Planning Commission Staff Report

Meeting Date: August 9, 2021

From: Chris Dietz, Planner

Description: **P.Z. 04-2021 Wings Corporate Estates, Lots 14 & 16 (Stock and Associates):**
A request for a zoning map amendment from the 'PI' Planned Industrial District to a new 'PI' Planned Industrial District for a 3.083-acre tract of land located at the southwest corner of the intersection of Wings Corporate Drive and Buzz Westfall Drive (18W440122, 18W440133).

SHEET TITLE:
PRELIMINARY DEVELOPMENT PLAN
SHEET NO.:
C1.0

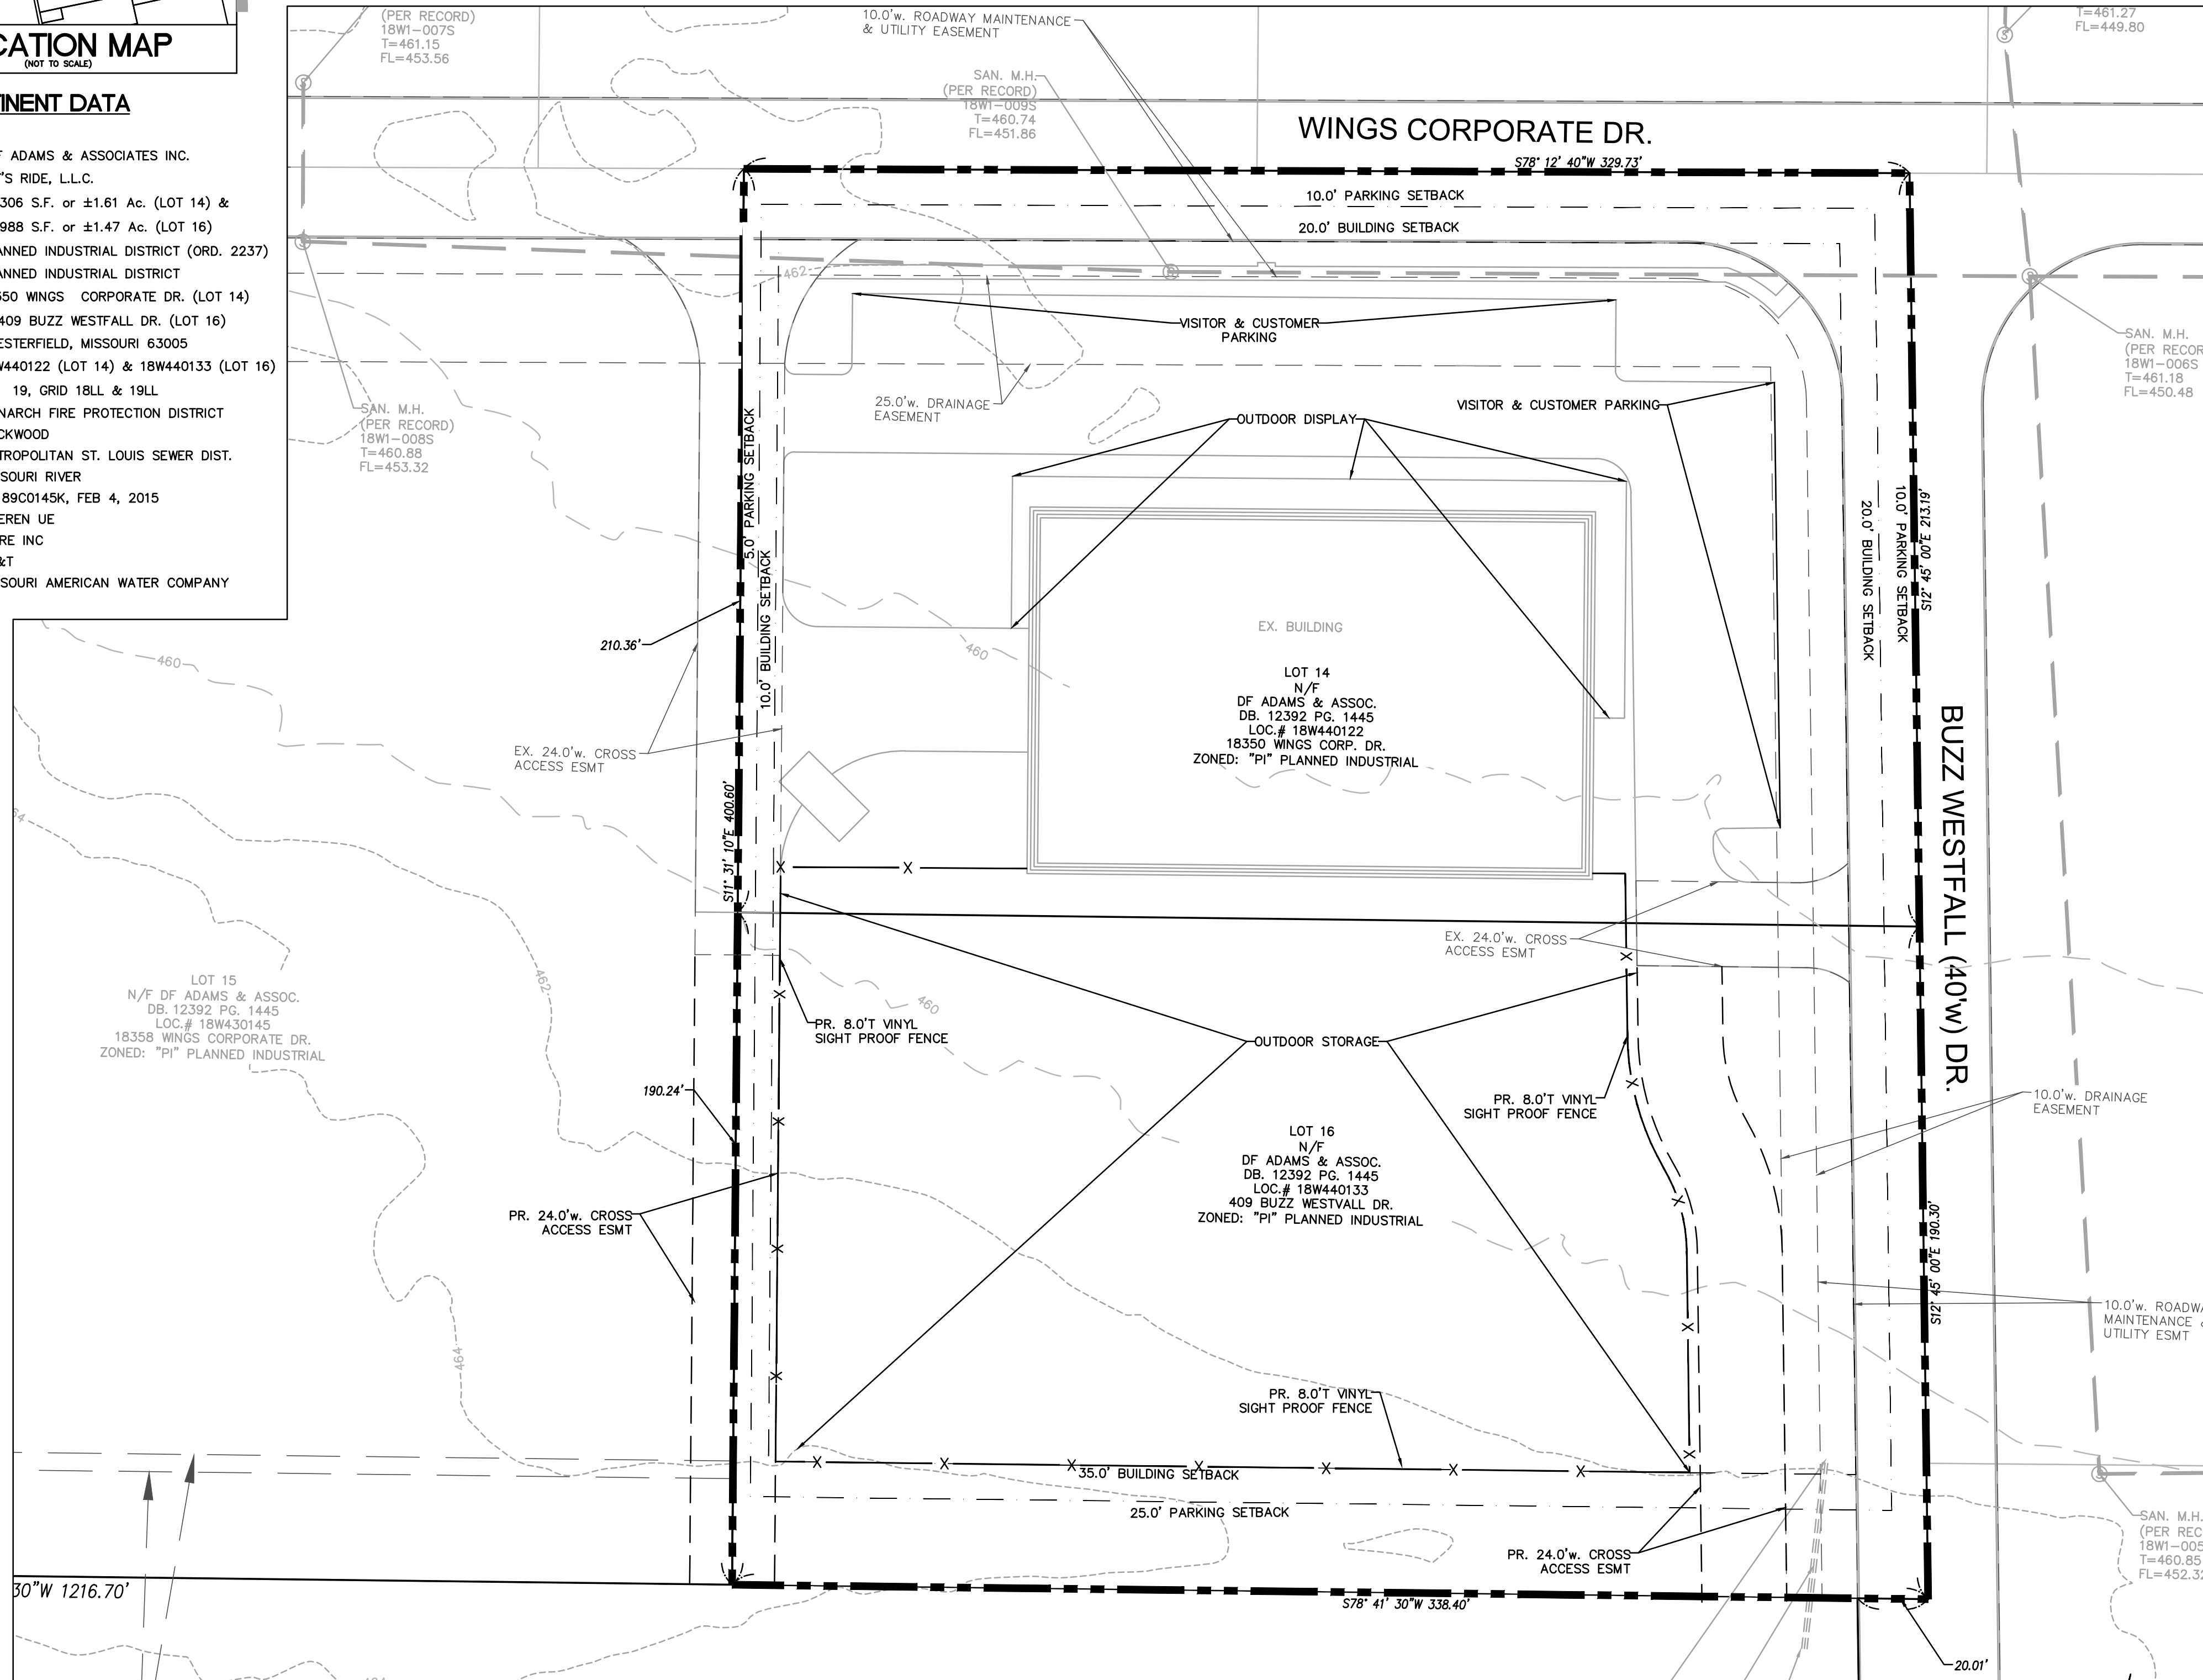
Issue: Planning Commission stated that the open space for this district align with the UDC requirement for “PI” —Planned Industrial District of 35% as opposed to 30% as requested by the applicant.

Issue: Substantial discussion was held by Planning Commission regarding how crates in the outdoor storage area were to be screened. The applicant mentioned that crates could be stacked up to four-high, or roughly twenty feet (20’). Planning Commission expressed concern as to how this will be fully screened from the site’s exterior and directed Staff to review screening requirements with the Applicant.

The request includes a Preliminary Development Plan that depicts the proposed outdoor storage area on Lot 16 for future expansion of the dealership use. This plan also depicts areas where vehicles would be placed on display during business hours around the north, east and west sides of the building. A survey has also been provided with the Preliminary Plan.

Applicant Response: The applicant has revised the project narrative and Preliminary Development Plan to reflect a 35% open space requirement.

Applicant Response: Applicant is amenable to Staff’s proposal that an eight-foot (8’) vinyl fence be located within structure setbacks to further screen these crates from view.

Applicant Response: The applicant is amenable to a minimum 35.0% Open Space for the entire district.

Applicant Response: The applicant is amenable to both the eight-foot (8') vinyl fence being located within the structure setbacks and the language as proposed by Staff regarding the visibility of stored goods from offsite.
